Model Validation: Modeling Study of PCB Contamination In The Housatonic River

A Peer Review

July 20, 2006

Figure 6.2-5 Comparison of Measured and Simulated Flow and Elevation at Five Stations During the October 2003 Storm Event

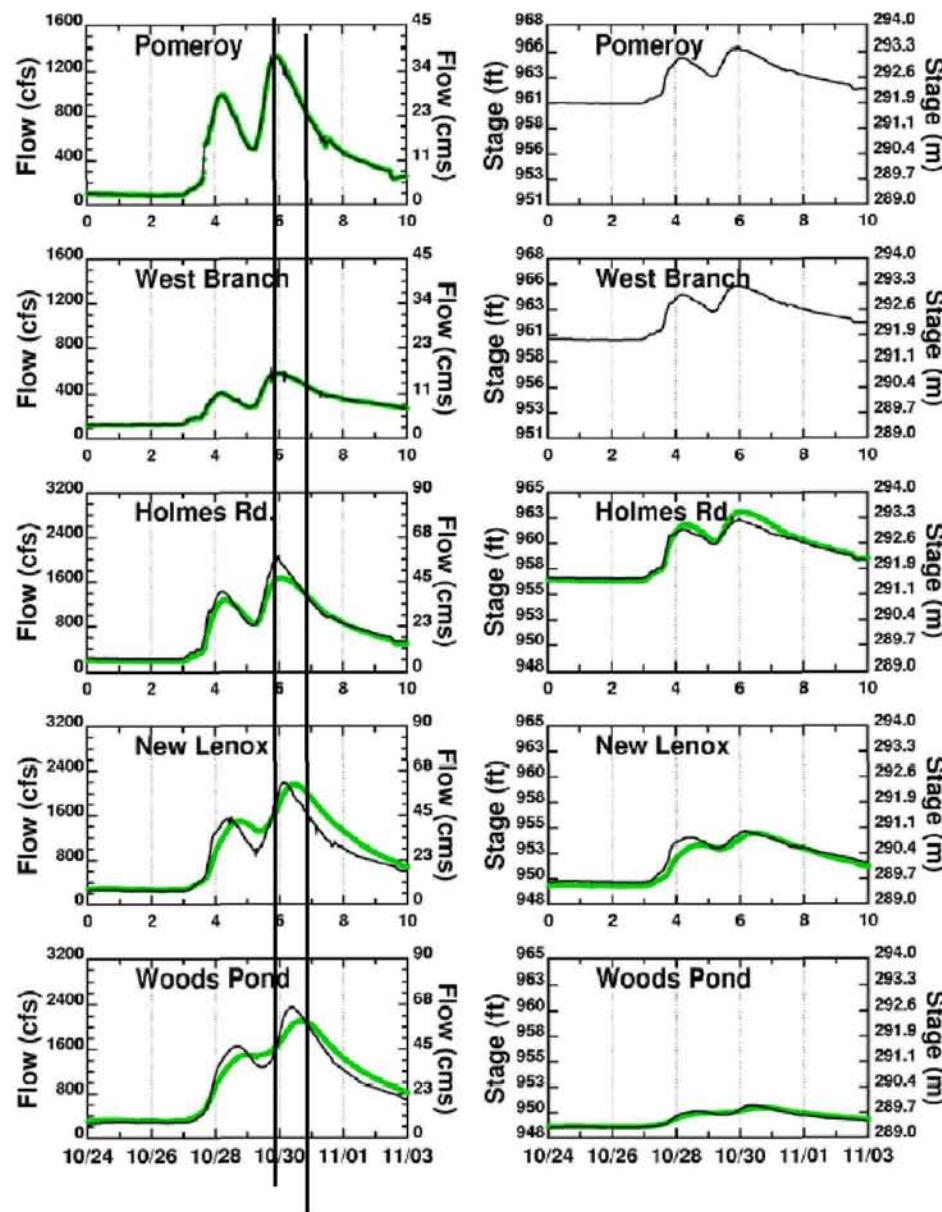
Given the importance of timing it is disappointing that the report provides so little detailed information on this factor and its effects. There is abundant reference to the model's ability to accurately reproduce event timing but these statements appear to be referring to timing in the most general sense. i.e. a precipitation event induces an increase in streamflow over a time similar to that observed. These references to "event timing" leave the question of the adequacy of the model simulation of timing with respect to flow velocities unanswered. Examination of several of the figures (see Fig. 6.2-5 (attached) e.g.) shows substantial differences between measured and modeled actual flow and stage timing at several stations along the PSA. In this figure, it would appear that the modeled speeds produced by the associated pressure gradients should be less than the measured and that the turbulence induced by adverse pressure gradients would also be reduced. Actual estimation is, of course, complicated by the morphology of the region with tributary inflows and/or backwater flows and storage complicating the simple stage discharge relationship. This factor may be the reason for example that the simulated flows at Holmes Road are higher than the measured despite a higher measured stage relative to that simulated.

Figure 6.2-8 Comparison of Measured and Simulated Velocities for Holmes Road, New Lenox Road, and Woods Pond Footbridge During the 26-Year Validation Period

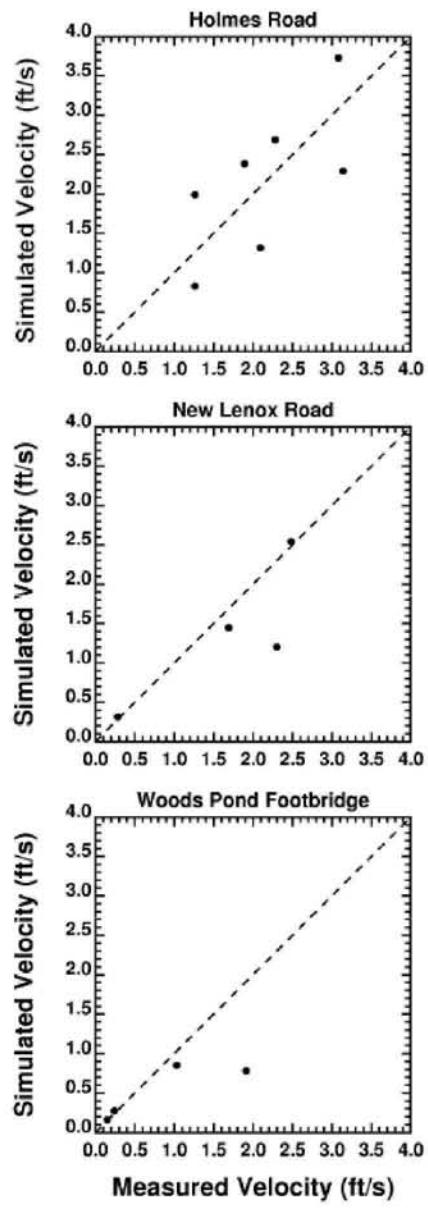
This matter of flow phase and velocity and associated effects on transport could be better evaluated if the report had provided a more complete discussion of measured vs. modeled velocities when presenting the results of EFDC hydrodynamic calculations (see pp.6-31 e.g.). Although the model uses HSPF generated flows at the upstream boundary, the resulting simulations are to some extent independent of the HSPF generated flow/stage through PSA and as a result may be less sensitive to this matter of stage timing. Speeds were measured using both electromagnetic and acoustic doppler currents meters for short periods of time at several locations within the PSA (see.Figs 4.2-26 and 6.2-8 (attached)). These comparisons, while taken to be generally acceptable, indicate to me that there is very likely a substantial difference in measured versus modeled sediment transport associated with these differences in velocity. These flow induced differences will require substantial "calibration" within the model to yield reasonable estimates of sediment/contaminant flux. Given the non-linearity of both the velocity/shear stress and the shear stress/transport relationships it will be unlikely that such calibration will result in accurate simulations across a wide range of flows. This may be the principal reason that the model, at least some locations, seems to over-predict TSS values at low flows while under-predicting them at high flows. The significance of such variations will tend to increase with the duration of the model run and may become more of a problem during the extended runs planned for the Corrective Measures Study.

Comparisons between measured and modeled velocities are complicated by the model use of a single grid cell across the main stem channel. If the single cell is to be retained measurements should be designed to yield cross-sectional averages as opposed to point measurements. The majority of available data do not appear to be suitable for this purpose.

Figure 4-21c. Depth profiles of GE high resolution cores collected within Woods Pond during 1994 - 1995.

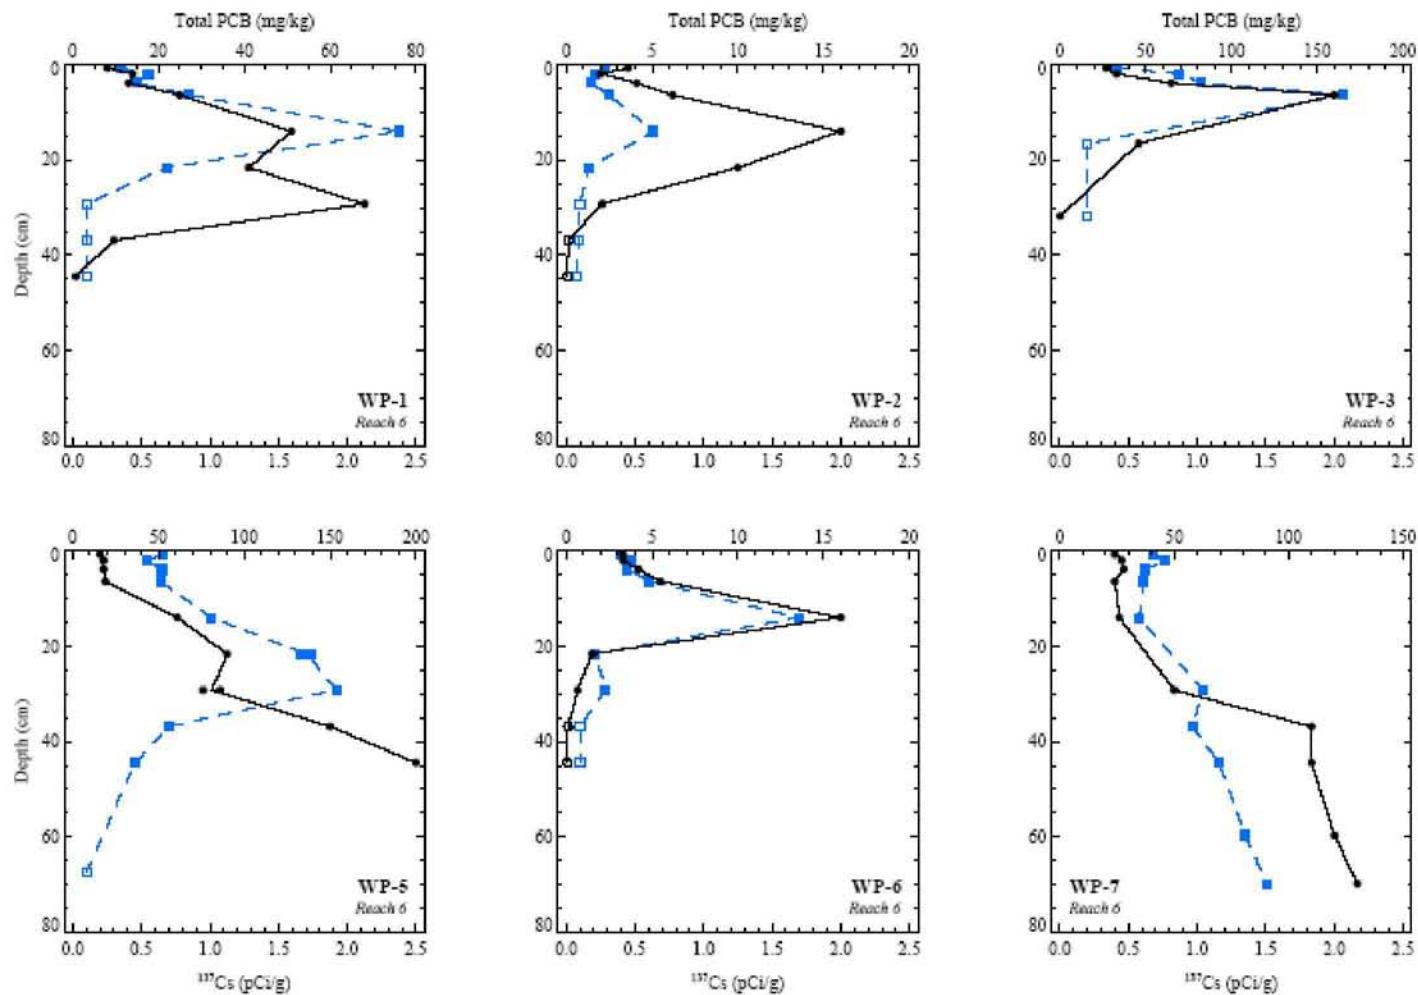
The model/data comparisons for PCBs should be extended to include consideration of distributions over the vertical. Any assumption of a well mixed layer extending over depths in excess of a few inches doesn't seem to agree with field data (see e.g. Fig. 4-21c, BBL,2003, attached). How are these differences to be reconciled ? (i.e. use of 6" well mixed layer vs. detailed core data showing little mixing beyond 1-2in). These core data and associated radio-dating also allow estimates of sedimentation rate to be compared to the mass flux data provided by the model. This comparison was not part of the validation report. It would provide an additional check on model results and is recommended.

been a matter of concern for some time. Experience in other riverine/bayou systems as well as the detailed core data (Fig. 4-21c, attached) indicate to me that the active bed used in the model is too thick. It may be that this specification in terms of physical transport characteristics has relatively little effect on overall model results (although that might bring up another set of questions). A test of model response to this characterization is recommended.
